Outer Dowsing Offshore Wind

Response to Section 51 Advice

Schedule of Changes for Plans

Document Reference: 2.0

Drawing No: 22000087_PLN_INFO_13230.4

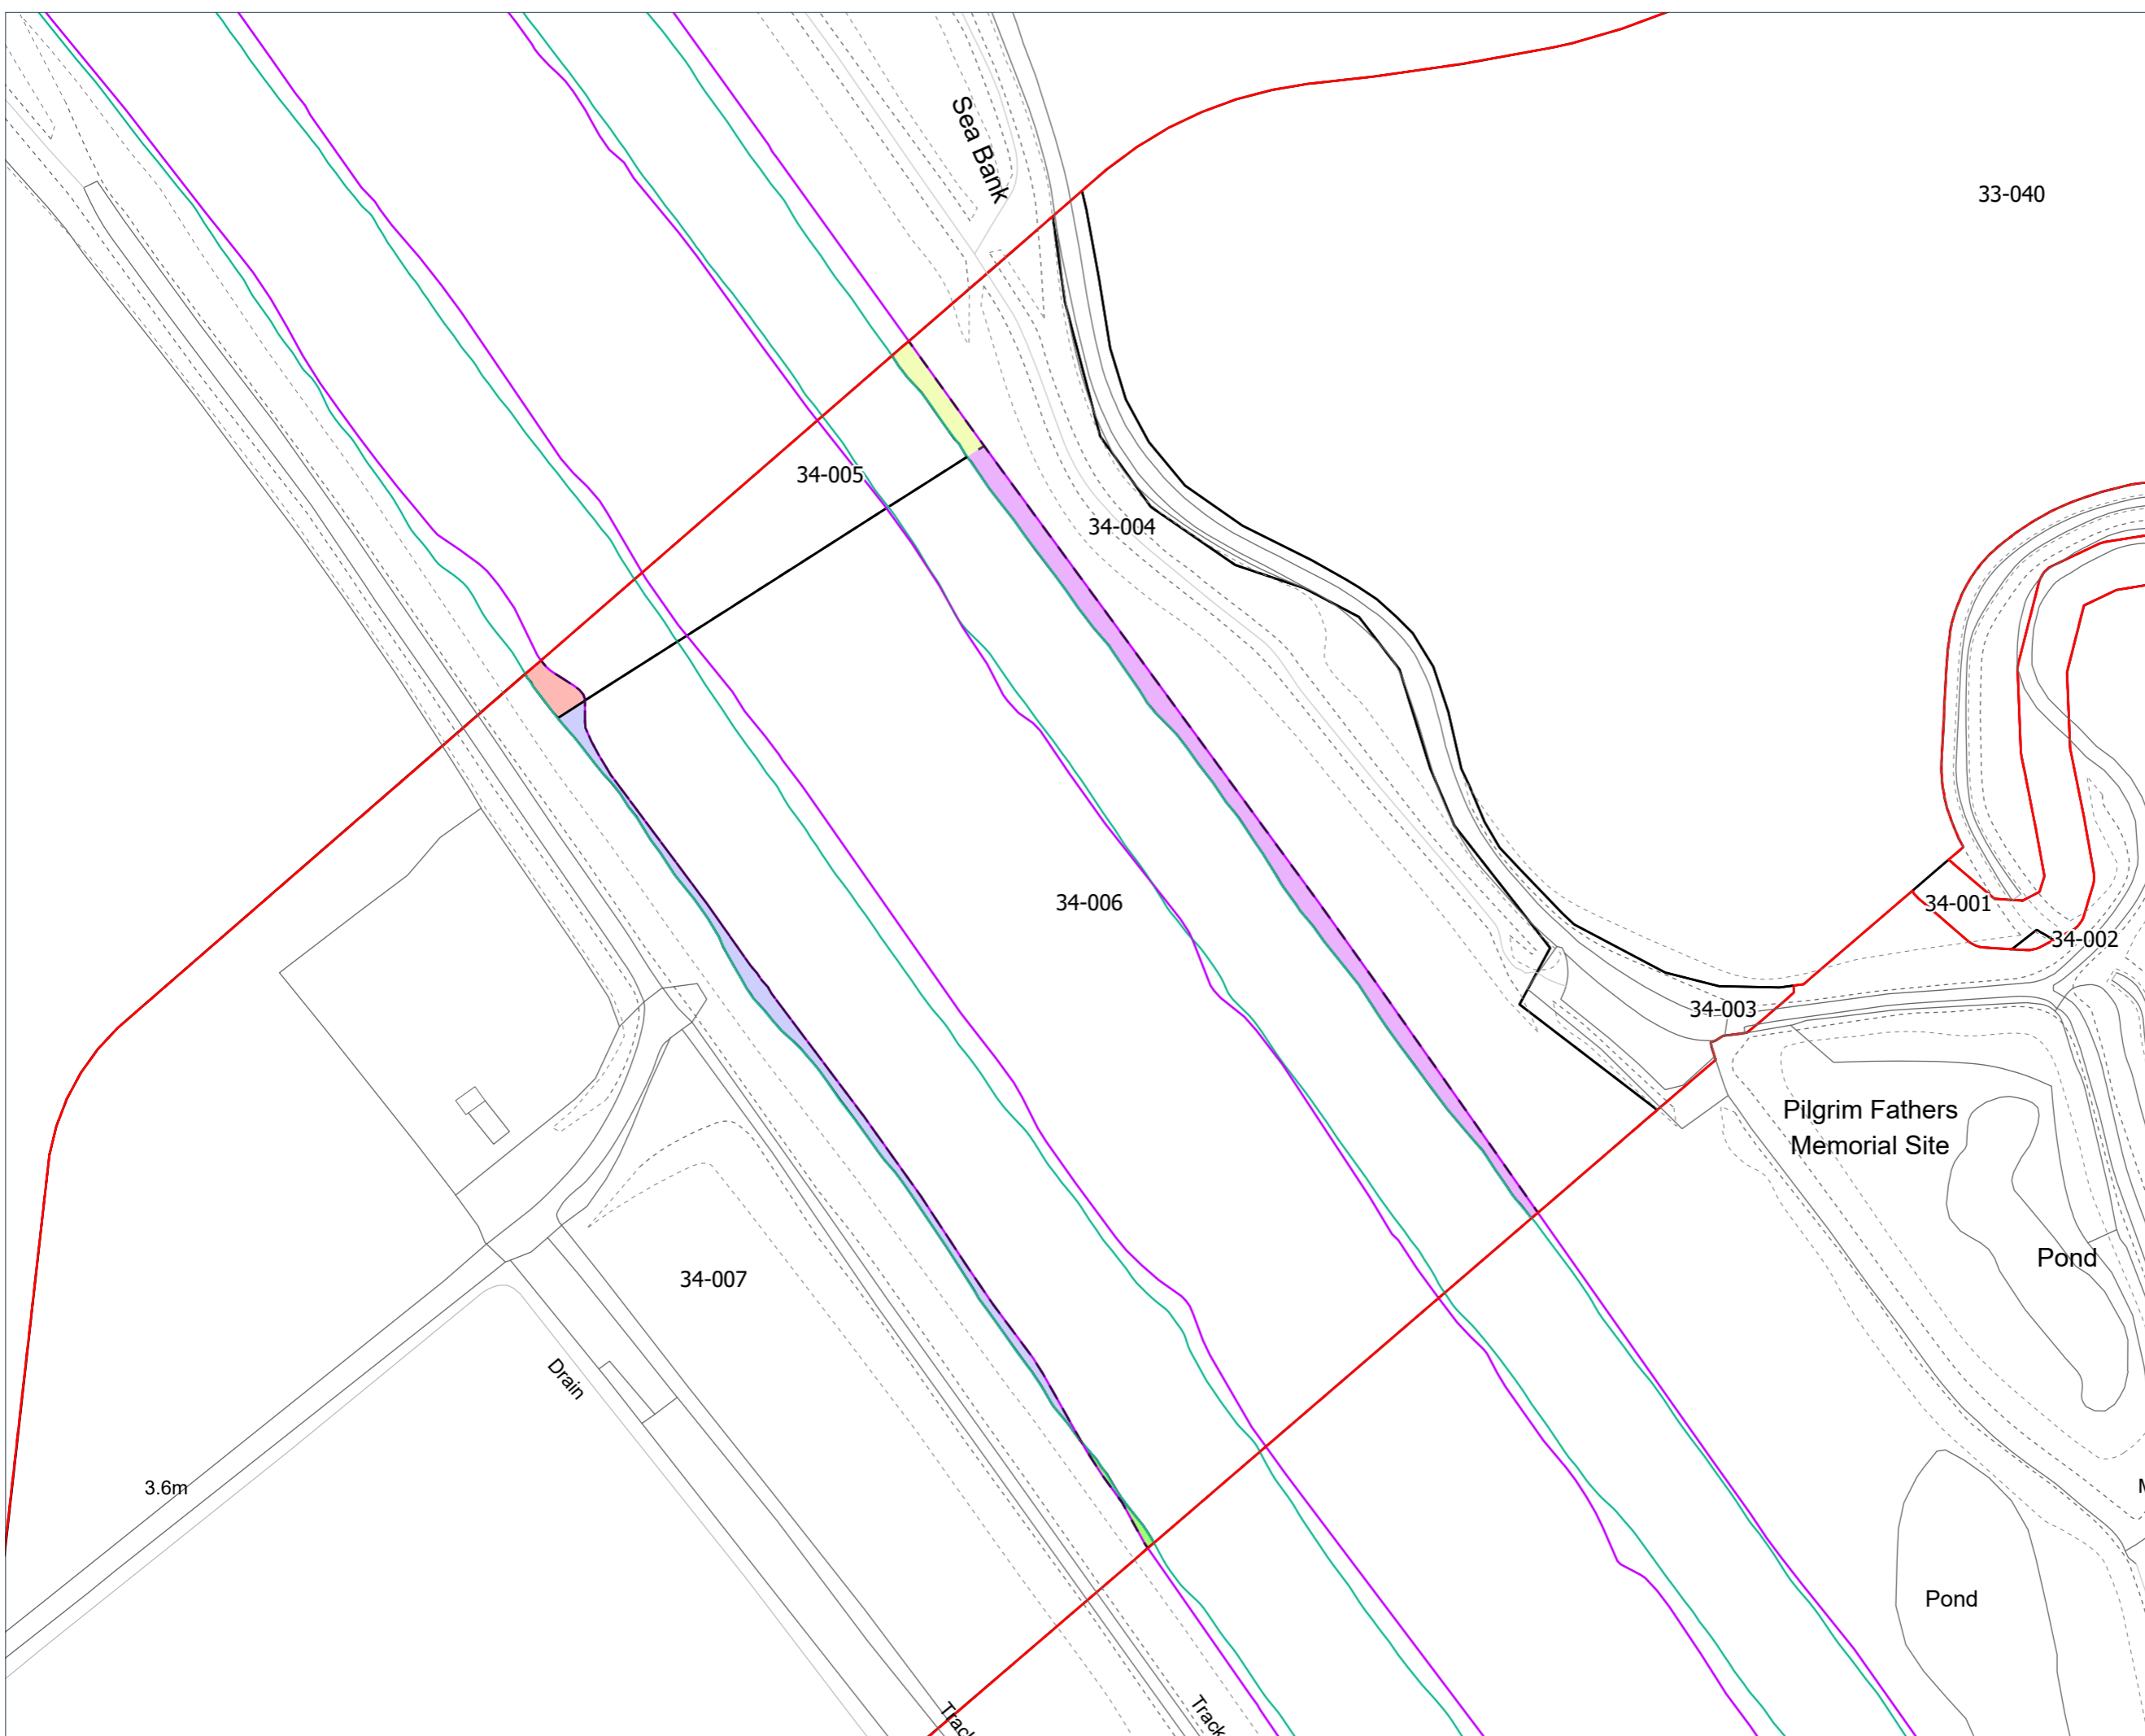
| Plan Numbers | Reference | Plot Number(s) if appropriate | Date of Change | Revision Change | Change Made | Reasons for Change |
|--------------|-----------|-------------------------------|----------------|-----------------|---|--|
| 2.5 | | 34-004 | July 2024 | V2 | Plot reshaped due to new mean high/low water mark update. | Plot extent updated following revised mean high/low water marks. Plot area increased from 6581.31m ² to 7341.42m ² . |
| 2.5 | | 34-005 | July 2024 | V2 | Plot reshaped due to new | Plot extent updated following revised mean high/low water marks. Plot area reduced from 1849.57m ² to 1808.34m ² . |

| Plan Numbers | Reference | Plot Number(s) if appropriate | Date of Change | Revision Change | Change Made | Reasons for Change |
|--------------|-----------|-------------------------------|----------------|-----------------|---|---|
| 2.5 | | 34-006 | July 2024 | V2 | Plot reshaped due to new mean high/low water mark update. | Plot extent updated following revised mean high/low water marks. Plot area reduced from 20132.73m ² to 19798.85m ² . |
| 2.5 | | 34-007 | July 2024 | V2 | Plot reshaped due to new mean high/low water mark update. | Plot extent updated following revised mean high/low water marks. Plot area reduced from 105198.16m ² to 104859.17m ² . |

Drawing No: 22000087_PLN_INFO_13230.7

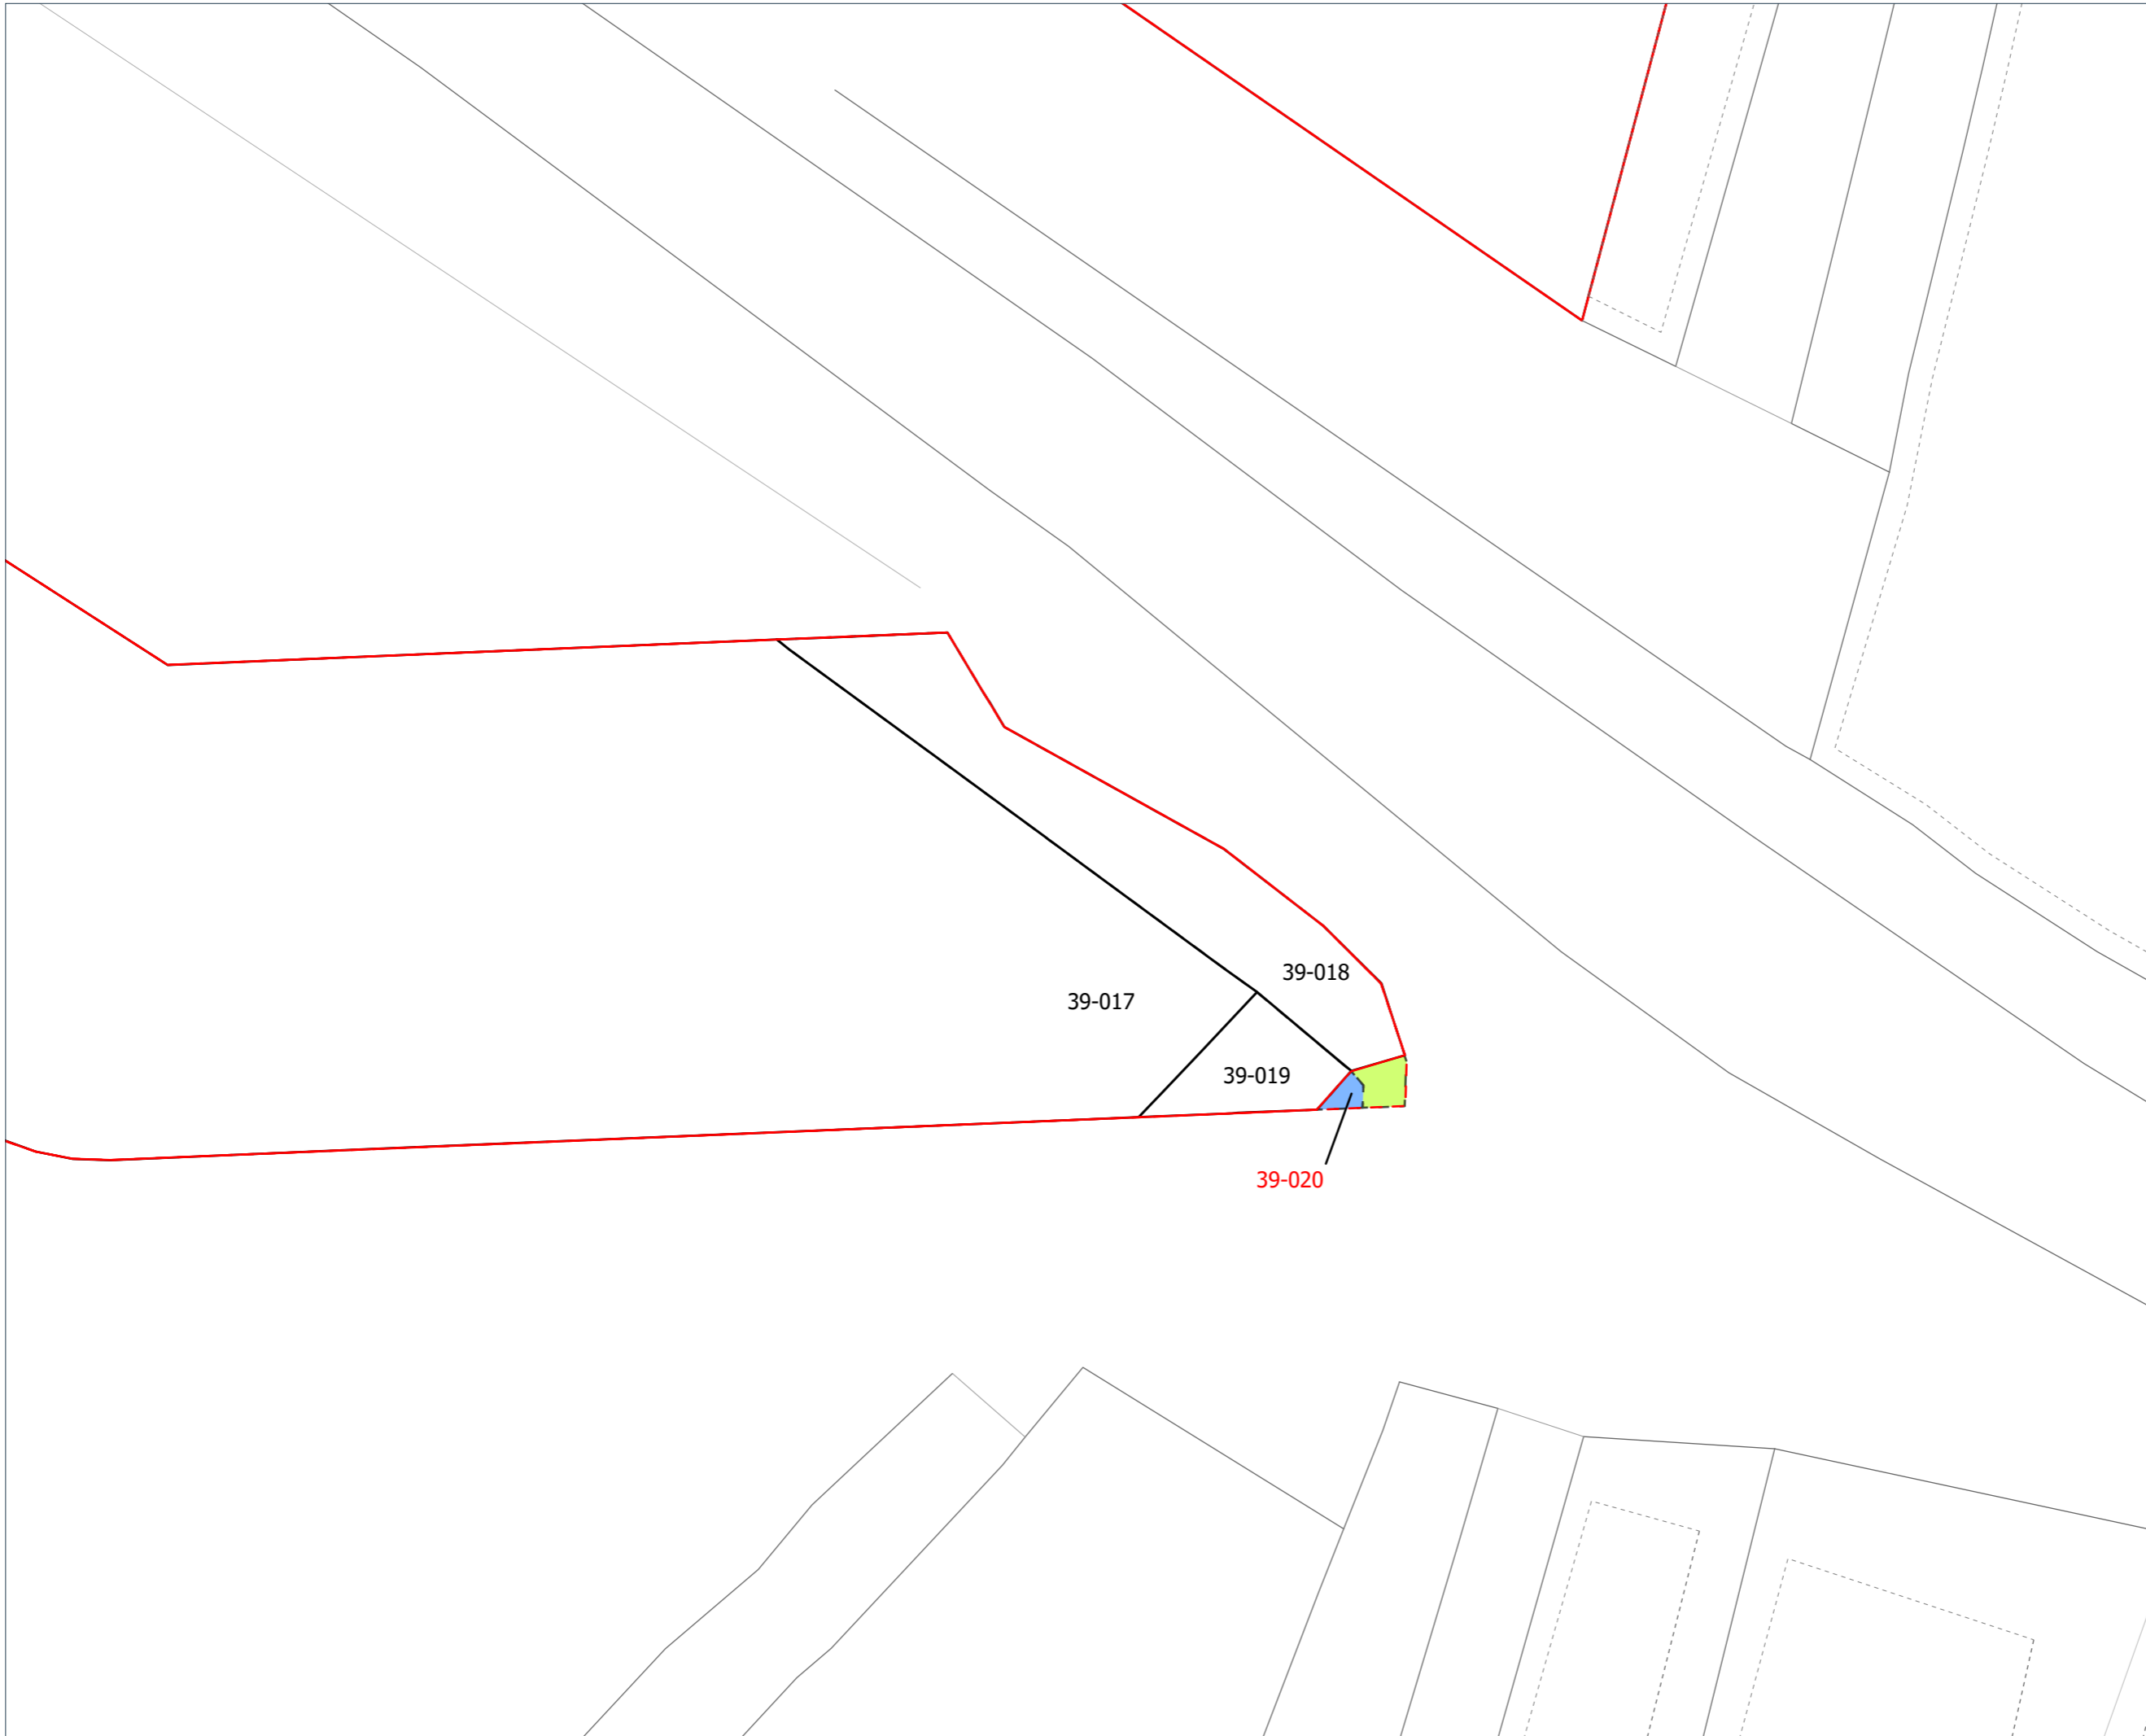
| Plan Numbers | Reference | Plot Number(s) if appropriate | Date of Change | Revision Change | Change Made | Reasons for Change |
|--------------|-----------|-------------------------------|----------------|-----------------|---|---|
| 2.5 | | 39-018 | July 2024 | V2 | Order Limits reshaped. | Re-shaped (reduced in size), area recalculated but plot description unchanged. Plot reduction made to reflect change to plot 39-020. Area removed as no longer required for temporary rights of access. |
| 2.5 | | 39-020 | July 2024 | V2 | Plot removed. | Plot removed from Order Limits due to plot not being required as part of the access. |

- Order Limits (July 2024)
- Order Limits (March 2024)
- Land Plot
- Previous Land Plot Extent
- Land Removed from Order Limits
- 0.85m² of land removed from plot 39-018 and Order Limits
